**DESIGN REVIEW TECHNICAL ADVISORY COMMITTEE MEETING**  
**November 16, 2015 | 4:00 P.M.**  
**Blairs Ferry Conference Room, City Hall**  
**101 First Street SE**  
**AGENDA**

## **DESIGN REVIEW TECHNICAL ADVISORY COMMITTEE STAFF REPORT**

Date: November 16, 2015  
Applicant: Thomas McInerny  
Owner: Brett McCormick  
Location: 219 16<sup>th</sup> Avenue SE  
Request: Façade Review  
Date Application Received: November 6, 2015

Project :  
**Restaurant**  
 219 16th Avenue SE  
 Cedar Rapids, Iowa

Sheet Title:  
**EXTERIOR ELEVATIONS**  
 Sheet Number:  
**A-201**

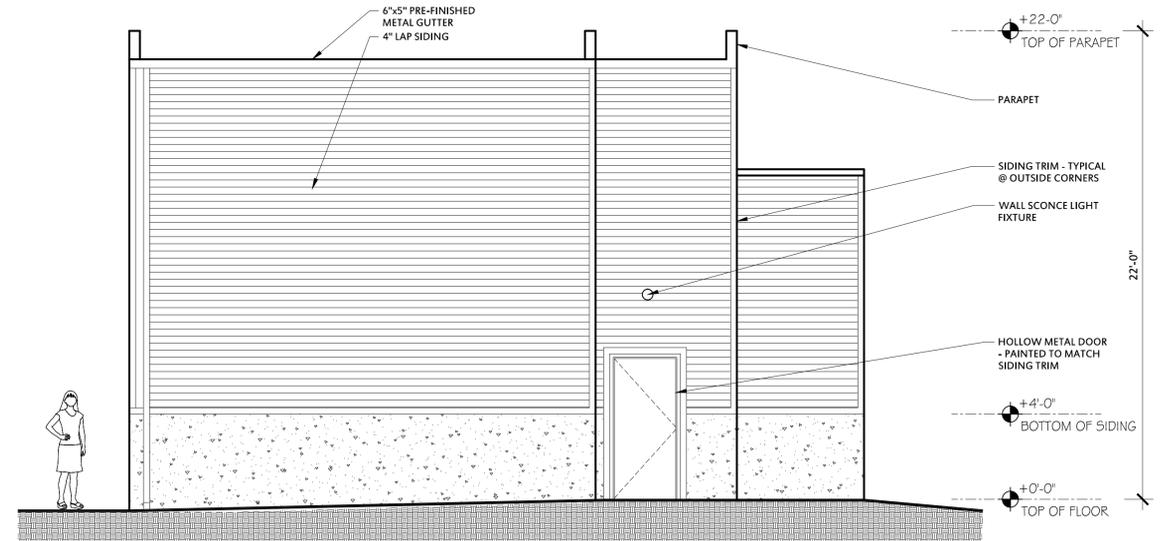
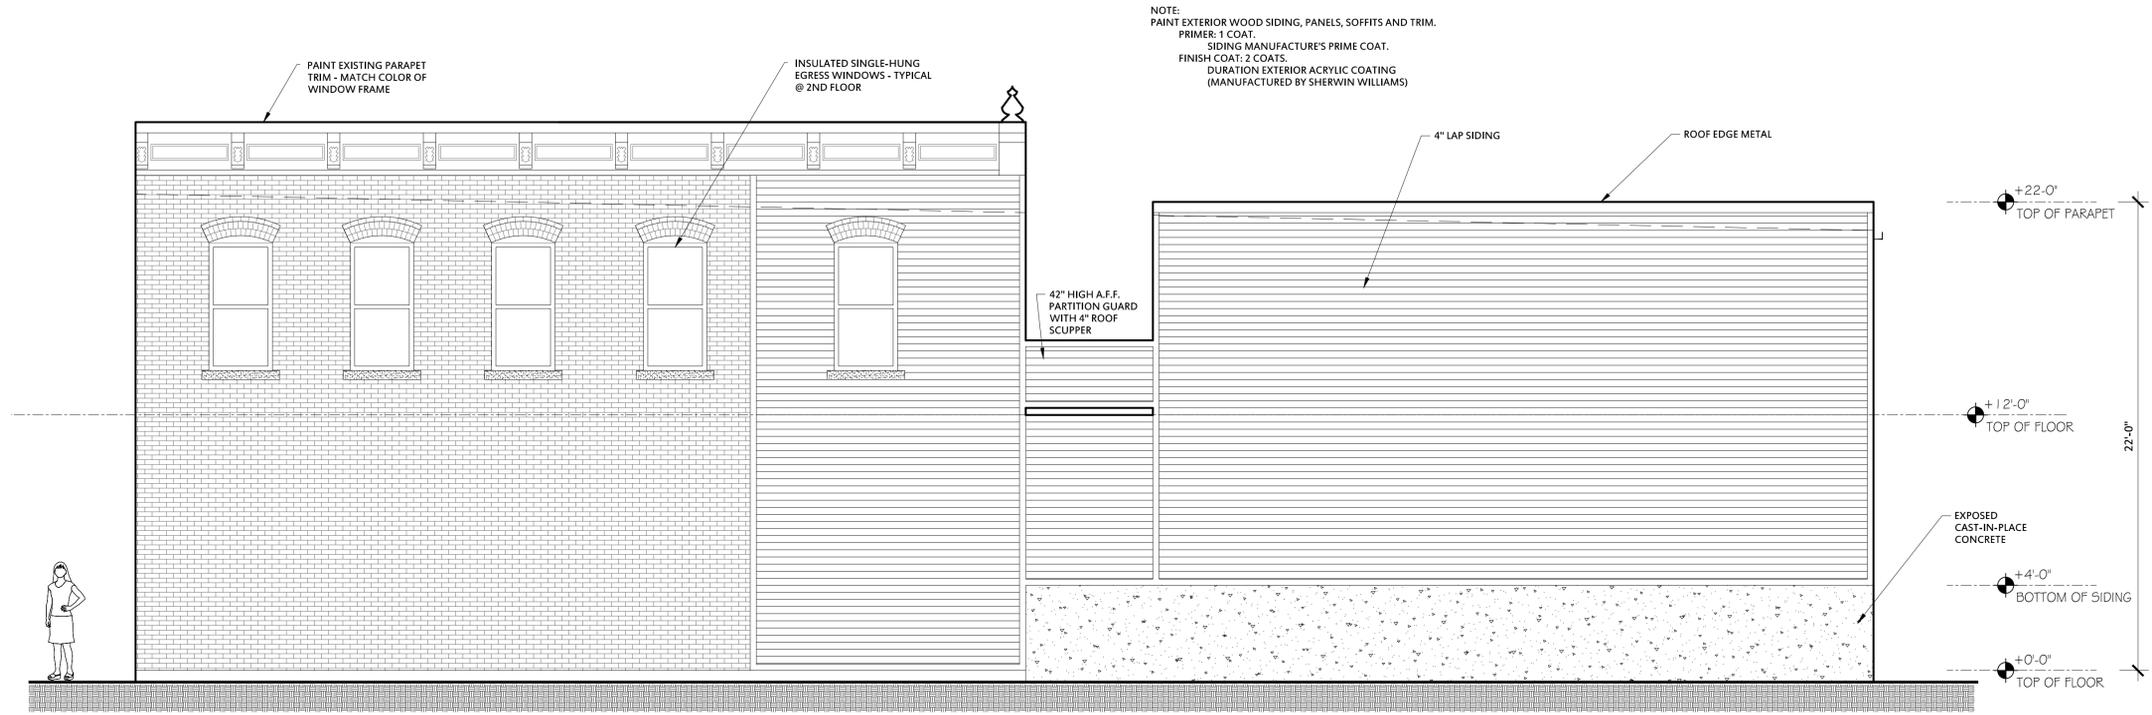
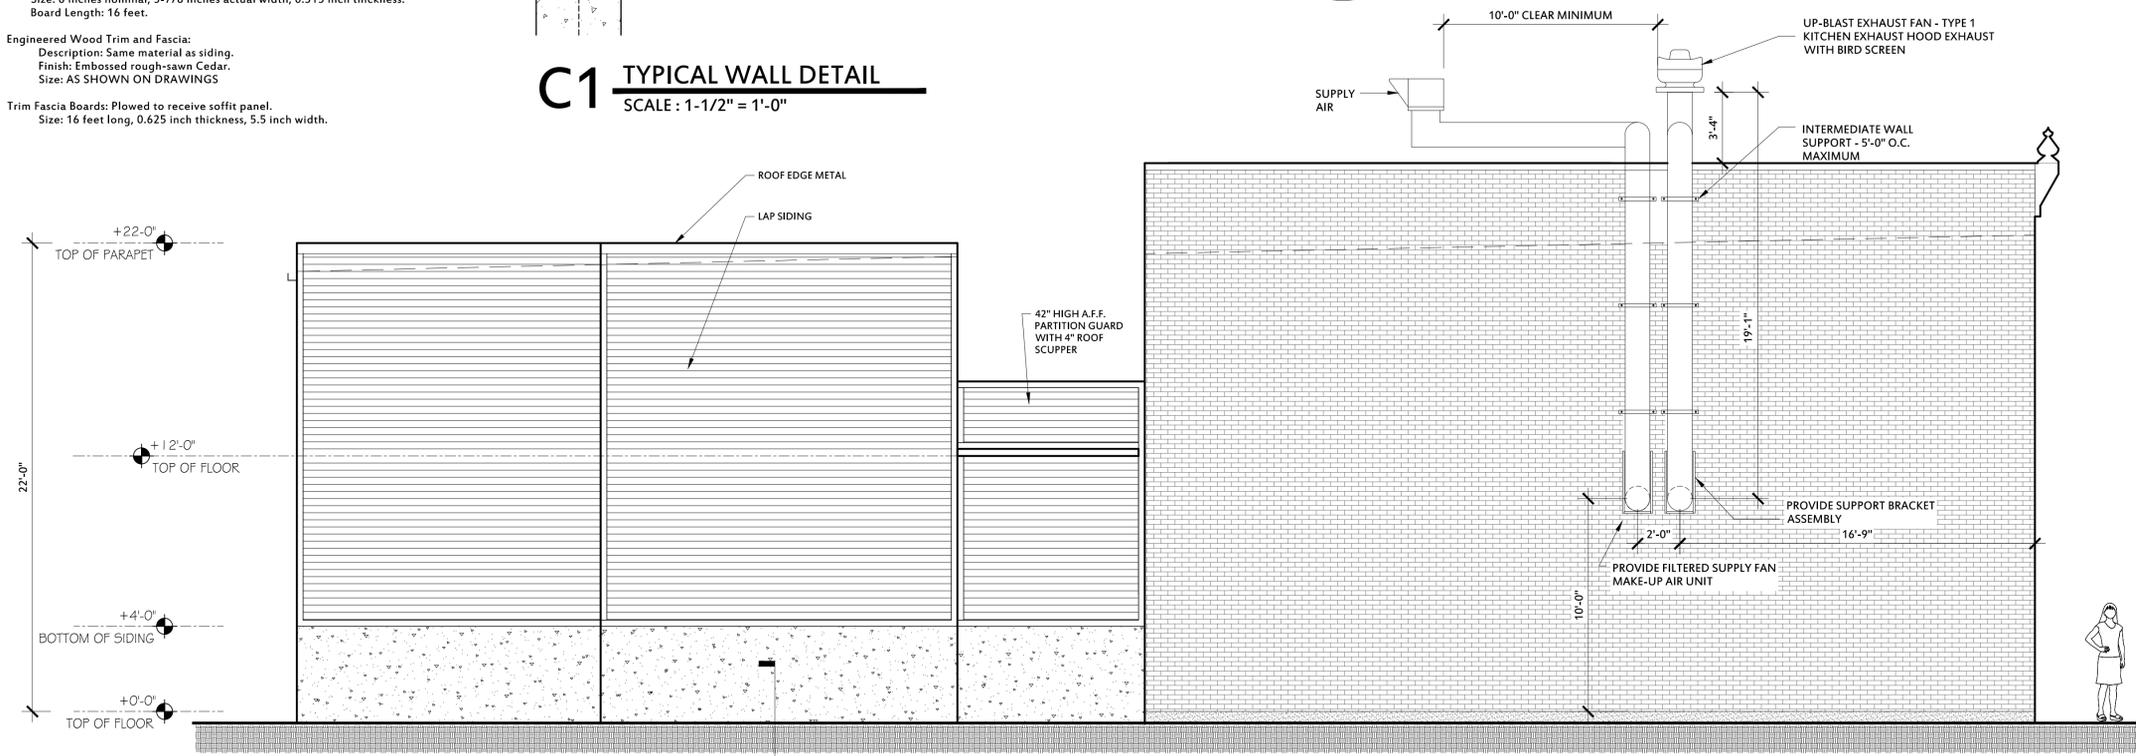
- Relocate or enclose the exhaust stack.

2) The top edge of the building shall be defined by a cornice line or similar articulation.		X		Proposed metal roof edge
3) Windows and doors shall be located, spaced and aligned on the building facade in a manner consistent with the established context of the block.		X		Windows are not proposed for the addition.

6) All new construction shall use compatible and traditional building materials such as brick, limestone and metalwork. A creative mix of materials consistent with the historic character of the area may be considered.		X		Proposing lap siding for addition.

7) Materials shall be used in a manner that incorporates architectural details, complementary textures and small scale elements, especially on the first floor of the primary façade.		X		Proposing lap siding for addition.
<b><i>Signage</i></b>
